# SOUTHWEST CONSERVATION DISTRICT

Re: Proposed Residential Development Recommendations  
139, 141, & 201 Turkey Roost Road and 30 Cobblers Hill Court

## Review of Proposed Development

**Photo 1.** Example of a Tree Filter from the CT Stormwater Quality Manual

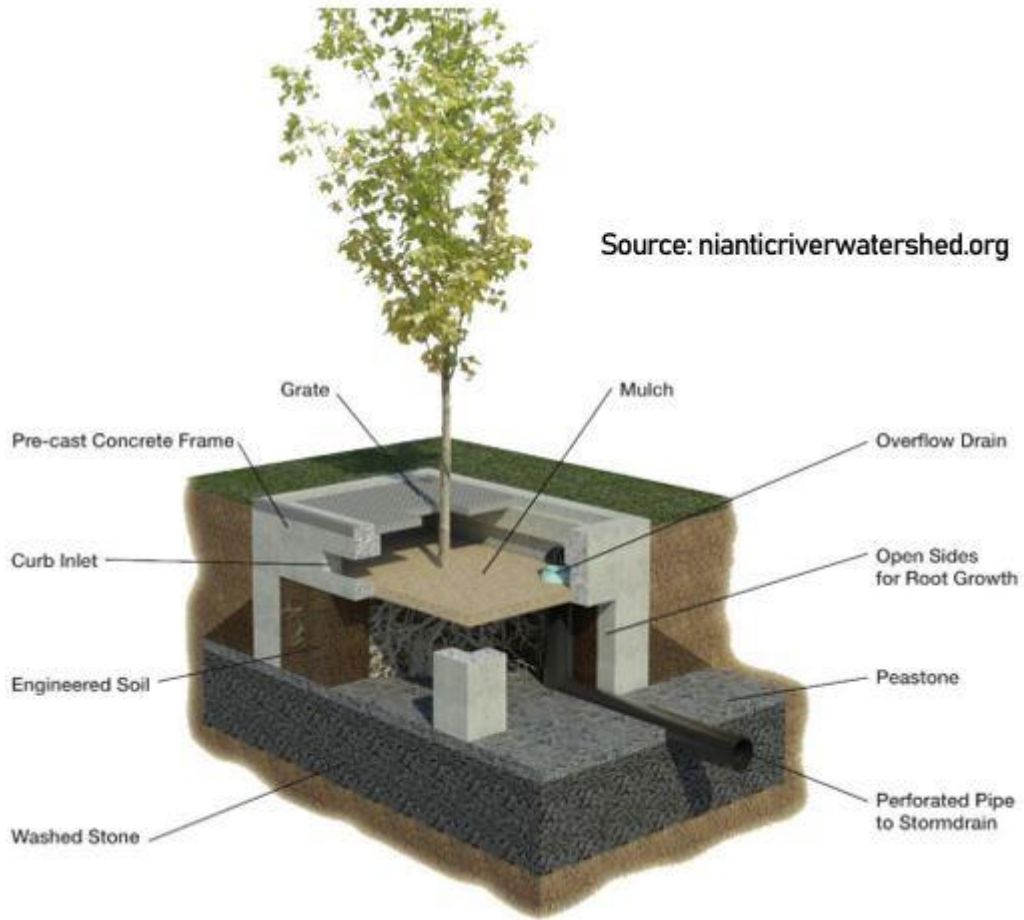
We recommend incorporating bioretention (**Photo 2**) and/or tree box filters (**Photos 1 & 3**) instead of just planting beds. Appropriate areas for implementation are along the sidewalk & road and islands in the street. This would increase the site's infiltration and lessen the peak flows to the riprap swales and infiltration loads on the stormwater ponds. These tree box systems can be connected to an underdrain system or be used as standalone infiltration systems. Also, an important component to these systems is a specific bioretention soil media mix that is comprised of 60–85% Sand, 15–25% Topsoil, and 3–8% Organic Matter (either sphagnum peat or wood derivatives) that helps with infiltration & filtration. Refer to the [CT SWQM 2023 DRAFT](#) (pages 303-320 and 321-335) for in-depth information.

**Photo 4.** Example of a Deep Sump Hooded Catch Basin from the CT Stormwater Quality Manual

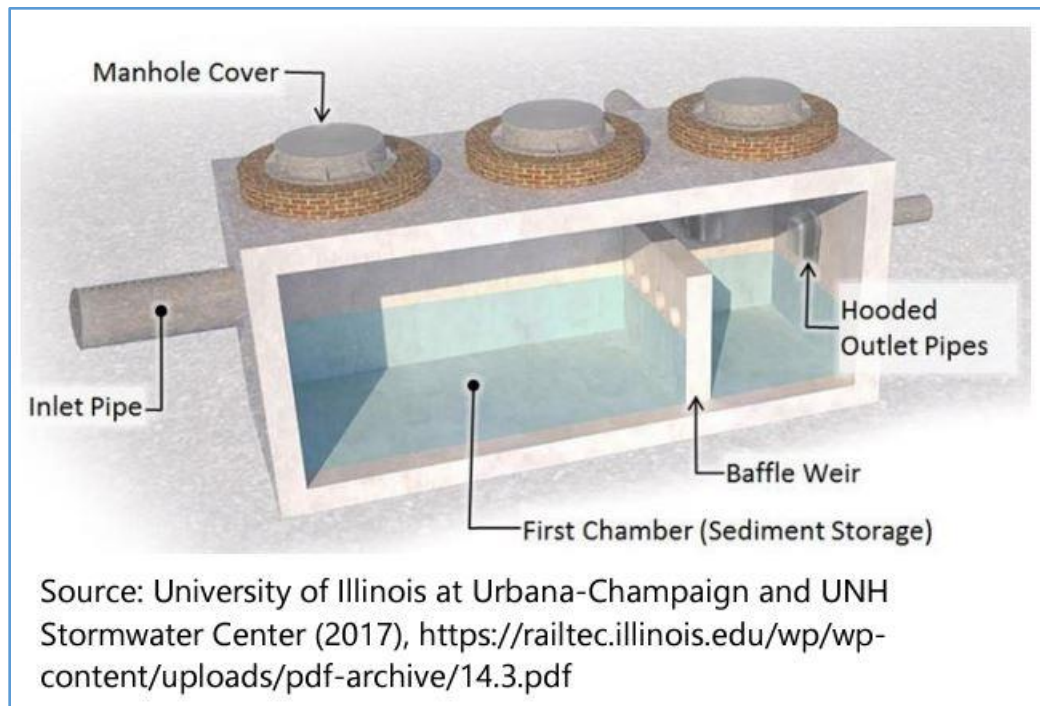
We recommend the addition of pretreatment BMPs, such as Deep Sump Hooded Catch Basins (**Photo 4**), Oil Grit Separators (**Photo 5**), and Proprietary Pretreatment Devices (**Photo 6**) in place of traditional catch basins. Pretreatment BMPs remove additional pollutants, such as sediment, oil, debris, nutrients, and bacteria, before stormwater is directed to the stormwater ponds. Refer to the [CT SWQM 2023 DRAFT](#) (pages 243-254) for in-depth information.
